<b>DOCKETED</b>	
<b>Docket Number:</b>	19-BSTD-03
<b>Project Title:</b>	2022 Energy Code Pre-Rulemaking
<b>TN #:</b>	235643
<b>Document Title:</b>	Home Ventilating Institute Comments - Response to CEC's Nov 3 Proposal to Establish Minimum Capture Efficiency for Range Hoods
<b>Description:</b>	N/A
<b>Filer:</b>	System
<b>Organization:</b>	Home Ventilating Institute
<b>Submitter Role:</b>	Public
<b>Submission Date:</b>	11/17/2020 12:17:22 PM
<b>Docketed Date:</b>	11/17/2020

**HVI Comment - Docket No 19-BSTD-03; Response to CEC's Nov 3  
Proposal to Establish Minimum Capture Efficiency for Range  
Hoods**

Re: Docket No. 19-BSTD-03, 2022 Energy Code Pre-Rulemaking; *Response to CEC's November 3<sup>rd</sup> Proposal to Establish Minimum Capture Efficiency (CE) for Range Hoods*

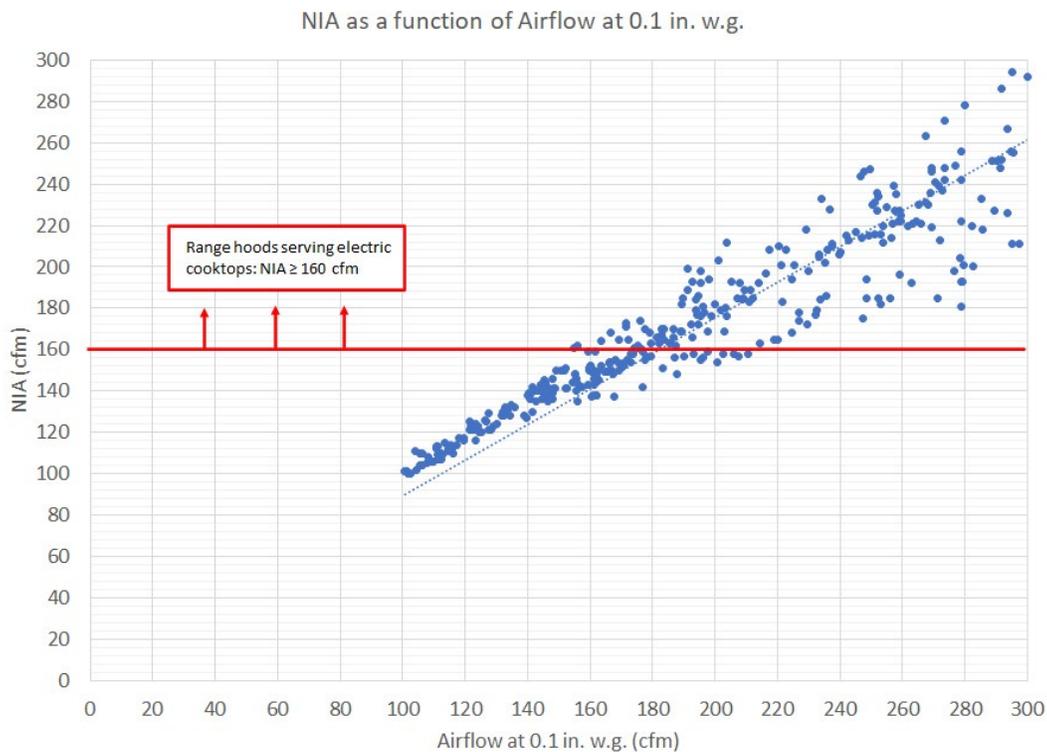
The rating metric that provides the closest approximation of a range hood’s “as installed” airflow is the nominal installed airflow (NIA), as defined in HVI 920. HVI developed NIA in 2020 at the recommendation of the ASHRAE Range Hood Rating Metrics Workgroup as a better representation of installed airflow than the range hood’s traditional airflow rating at 0.1” w.g. NIA is calculated from the intersection of a range hood’s fan curve and a system curve that is considered “typical” (i.e., 10 feet of smooth duct, two elbows, a termination fitting, and a duct diameter that is equivalent to the range hood’s duct take-off). Because NIA can be calculated from existing test data, no additional testing is required to produce the rating. As a point of comparison, HVI has performed an initial analysis<sup>3</sup> of over 840 range hoods listed in HVI’s CPD to determine the relationship between NIA and rated airflow at 0.1” w.g. The analysis shows a good correlation between NIA and airflow at 0.1” w.g. on the dataset as a whole (see Figure 1); however, there is significant deviation across individual products of rated airflows at 0.1” w.g. for any given NIA. As such, and because HVI expects to publish NIA ratings in the CPD no later than Q2 2021 (well in advance of Title 24-2022 becoming effective), HVI recommends that beginning with Title 24-2022, CEC references NIA wherever a rated airflow is required for range hoods (and eliminates any references to range hood rated flow at 0.1” w.g.). HVI proposes that the “as installed” airflow either be verified by a HERS rater using the range hood’s rated NIA or using the Field Verification and Diagnostic Testing of Mechanical Ventilation Systems procedures in the Reference Appendices (i.e., RA3.7 or NA2.2, as applicable).

to illustrate the range of rated airflows at 0.1" w.g. that can be expected to be associated with an "as installed" or NIA airflow. For example, an NIA of 160 cfm (CEC's proposed upper-end target for electric cooktops) is likely to be associated with a rated airflow of 155-220 cfm at 0.1" w.g. If CEC were to reference 0.1" w.g. instead of NIA to verify an "as installed" airflow, then CEC would need to select the upper airflow rate of 220 cfm at 0.1" w.g. to have good confidence that the product would achieve an "as installed" airflow of 160 cfm. This could result in over-ventilation, as some products that are rated at 220 cfm at 0.1" w.g. are likely to deliver up to 215 cfm "as installed", which is well beyond the targeted, "as installed" airflow of 160 cfm for electric ranges.
